Subject: Issuance of Amendment No. 19 to Facility Operating License NPF-12 Virgil C. Summer Nuclear Station, Unit No. 1

AMENDMENT NO. 19 TO FACILITY OPERATING LICENSE NO. NPF-12 - Virgil C. Summer Unit 1

SAFETY EVALUATION BY THE OFFICE OF NUCLEAR REACTOR REGULATION
RELATED TO AMENDMENT NO. 19 TO FACILITY OPERATING LICENSE NPF-12

Figure 3.2.4 Rod Bow Penalty as a Function of Burnup

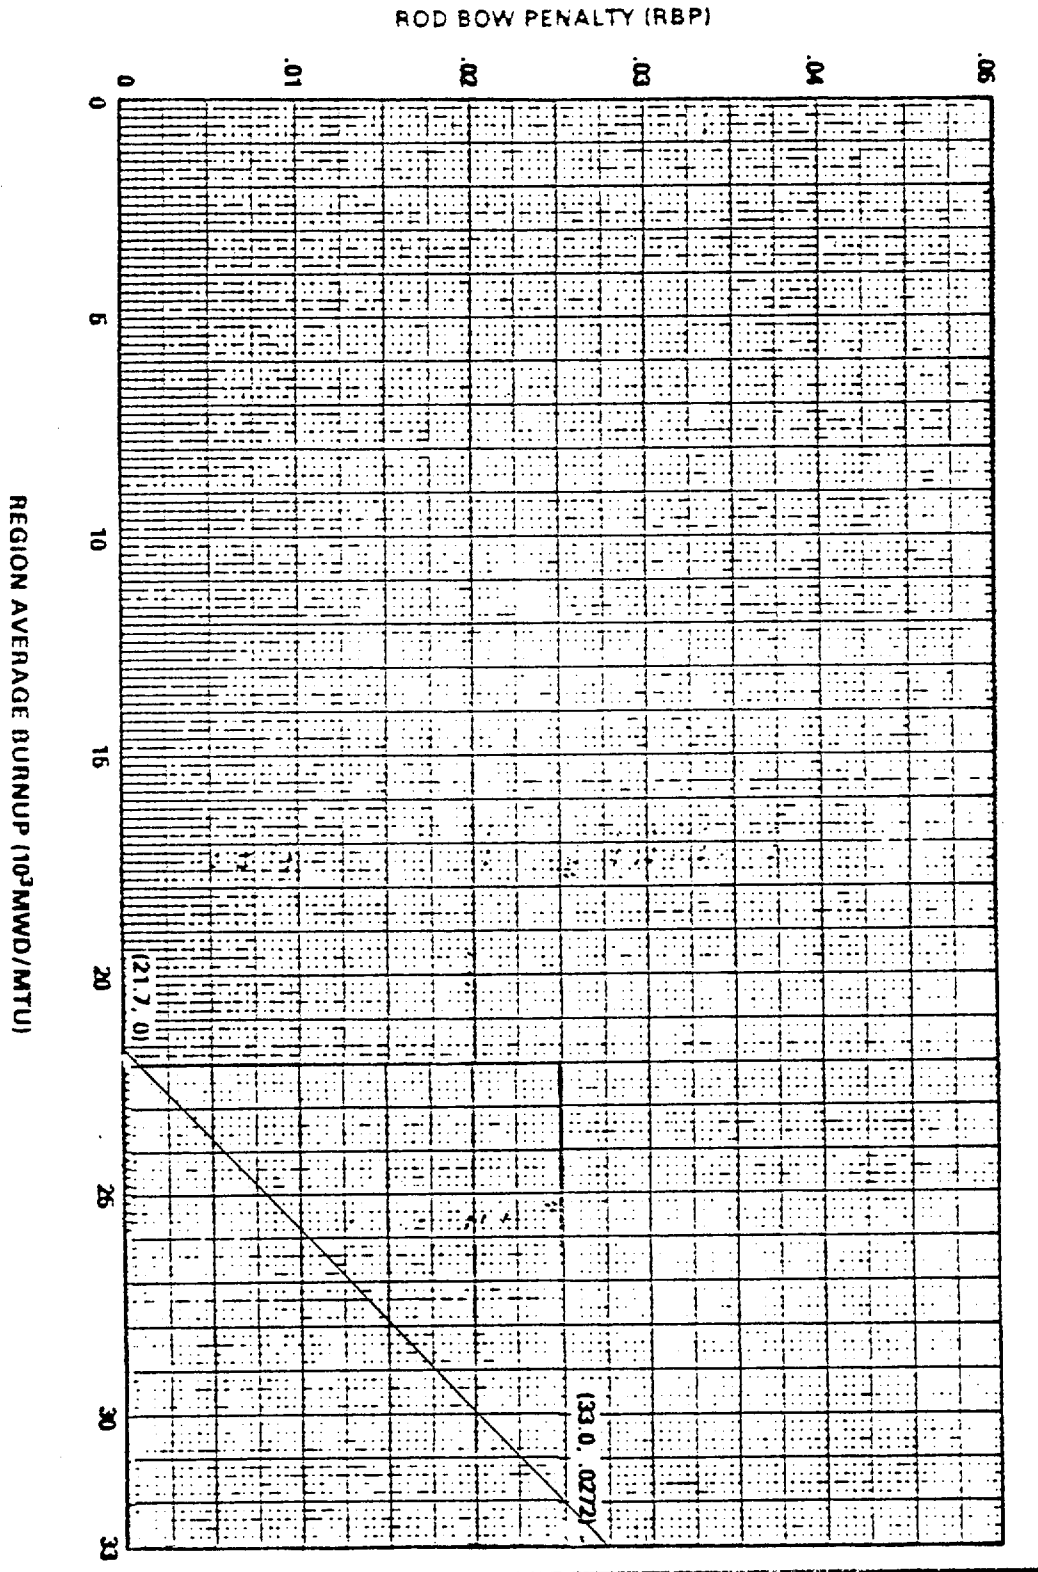
Figure 3.2-4 specifies the rod bow penalty as a function of burnup. The figure consists of two data points with a straight line drawn between them. The data points are correct; however, one of the data points (33, .0272) is plotted incorrectly resulting in an incorrect figure. This amendment corrects the plot of the data point and redraws the straight line.
